**DECISION 2002.01**  
**RESPECTING**  
**THE AMENDMENT**  
**TO THE**  
**TERRA NOVA DEVELOPMENT PLAN**

**OCTOBER 2002**

**Terra Nova Development Plan Amendment  
Decision 2002.01**

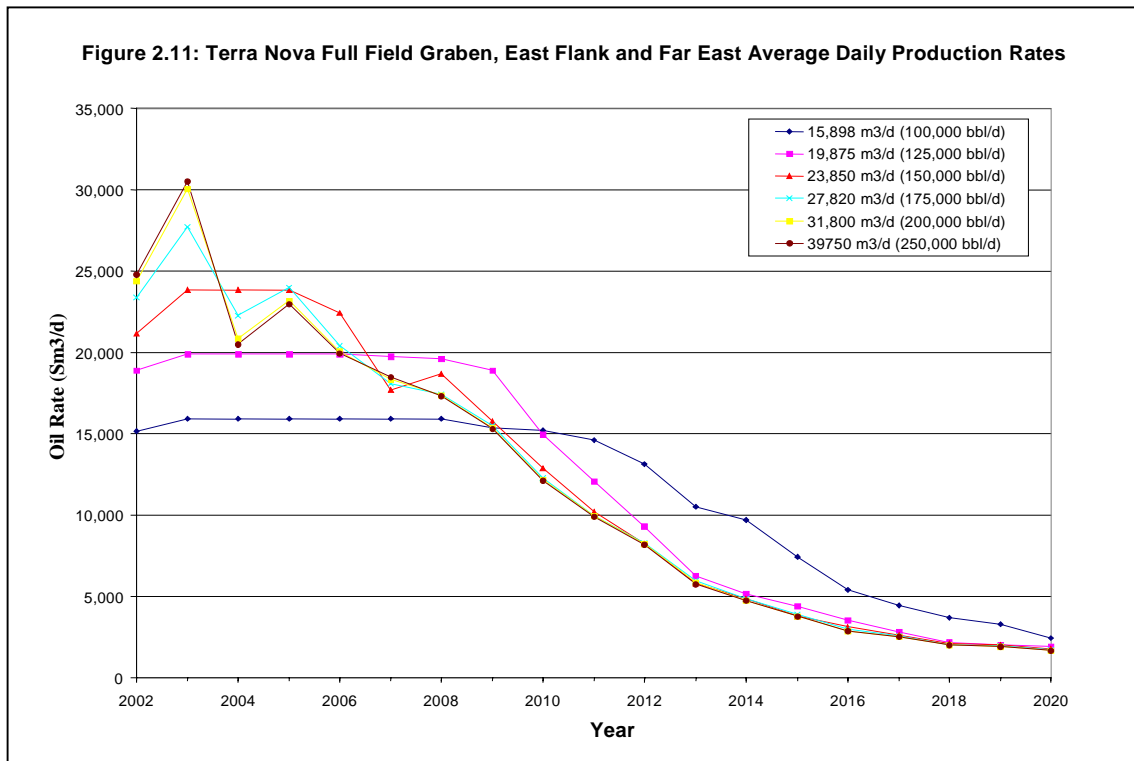
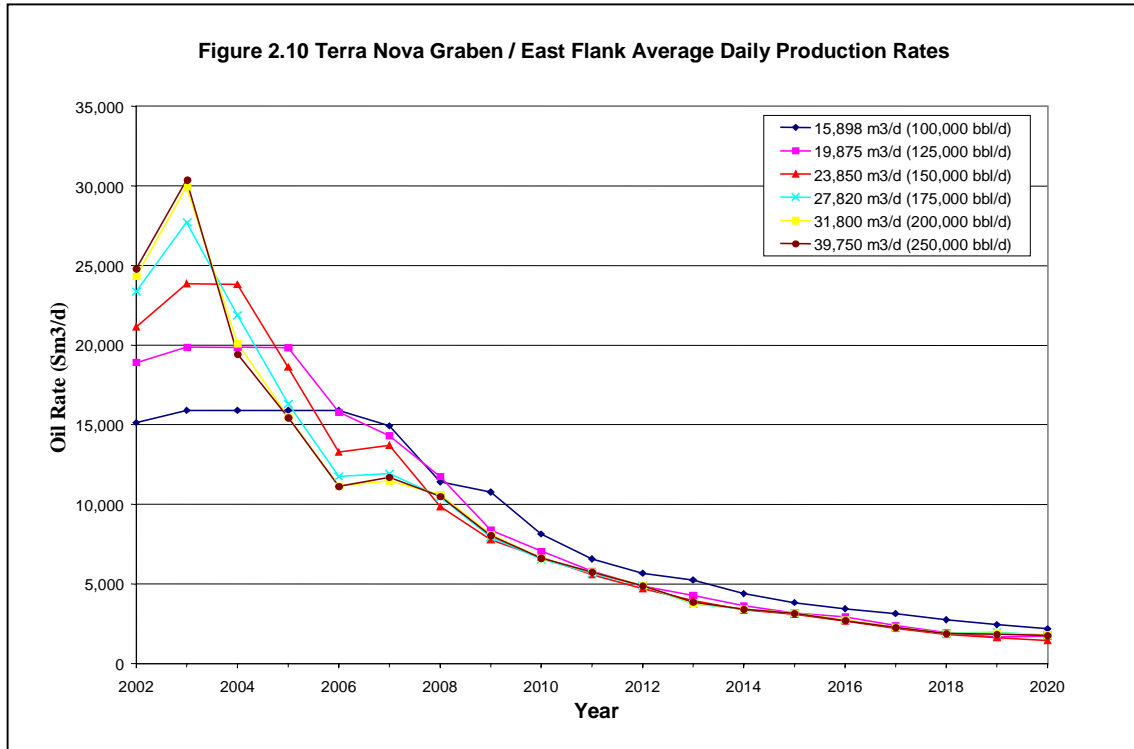
With respect to the Proponent's request to increase the annual oil production rate to 31 800 m<sup>3</sup>/d, the model studies support the view that oil recovery will not be adversely affected; there are no waste issues. The reservoir simulation model is an important tool to assess the reservoir performance and optimize depletion schemes to maximize recovery. However, the model is only as good as the data used to construct it, and it is important that a comprehensive data set be acquired to verify the reliability of the model and to update the model. The production data to assess fluid movement through the various sandstone intervals and across faults should be acquired early. With higher production rates, this becomes more important as the displacement process is occurring more quickly. The Board believes that a robust data acquisition program is necessary to obtain information in a timely manner to monitor the water and gas floods and to update the reservoir simulation models. This includes running production logs in selected development wells to assess inflow performance of the various sandstone units, and running appropriate production and saturation logs in development wells following water or gas breakthrough when conditions are such that reliable information can be acquired. It may be possible to acquire information from monitoring performance of producing and injection wells and wireline pressures acquired from newly drilled development wells.

While there are uncertainties surrounding the geological interpretation, communication between sandstone units and across faults and oil-in-place estimates, these are not unusual for most field developments. As additional wells are drilled and production data acquired, these will be resolved. The Board believes that these issues may affect the number of wells and sidetracks required to deplete the oil reserves, and the Proponent's ability to maintain production rates. The uncertainties are not expected to alter the conclusions of the Proponent respecting rate sensitivities. The Board notes that the Terra Nova field production performance, in terms of the stability of the oil processing facilities and performance of the reservoir, since production was initiated on January 20, 2002, has exceeded expectation. While there is uncertainty, overall the oil-in-place estimates have been within previous predictions. The production information acquired to date demonstrates good connectivity in the fault blocks with producing wells.

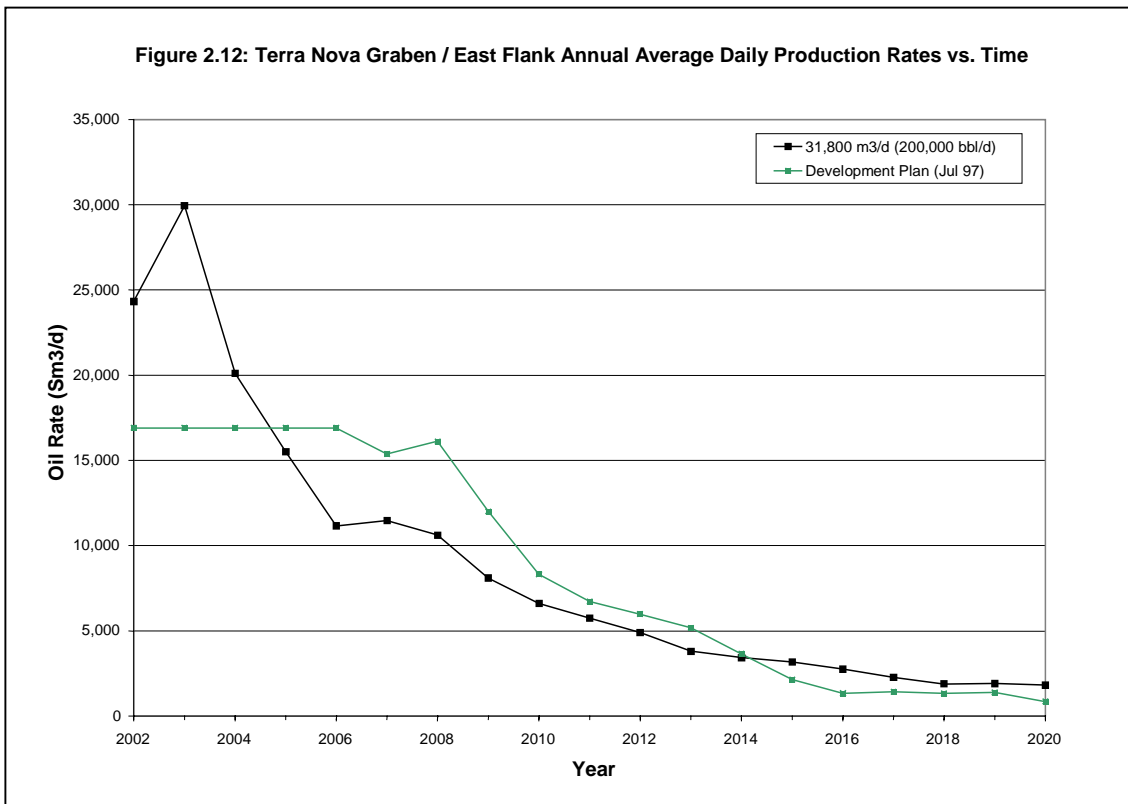
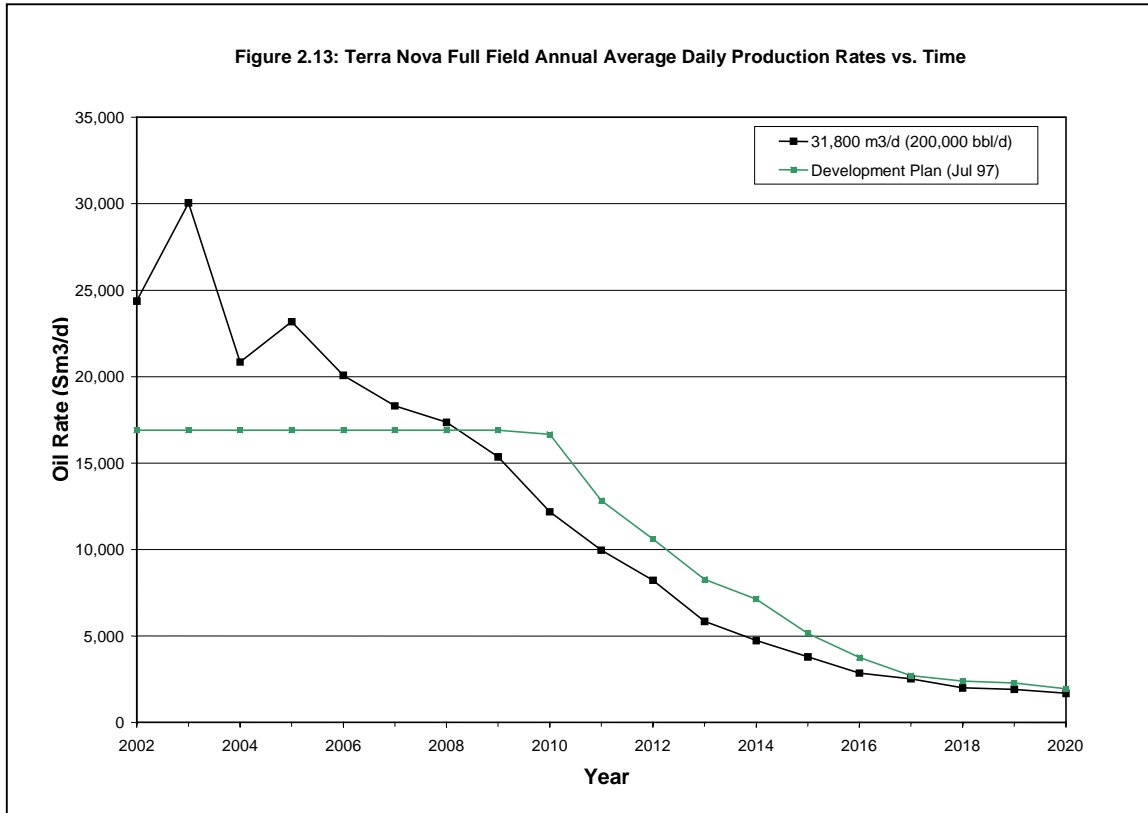
For the Terra Nova project, Figures 2.12 and 2.13 show the projected life of field for the original Development Plan Approval rate of 16 000 m<sup>3</sup>/d (100,600 b/d) and at the maximum requested rate of 31 800 m<sup>3</sup>/d (200,000 b/d) based on partial and full field depletion scenarios.

The graphs show:

- at 31 800 m<sup>3</sup>/d (200,000 b/d) the period during which peak production can be sustained is very short; and,
- at the end of the production curve, there is no significant difference in the rate at which oil is being produced in either case.

It is clear the affect on life of field resulting from the production rate increase is minimal. Given the significant improvement in the economic return to both owners and governments from the higher level of peak production in the early years, the Board's view is that the production rate increase should be approved.
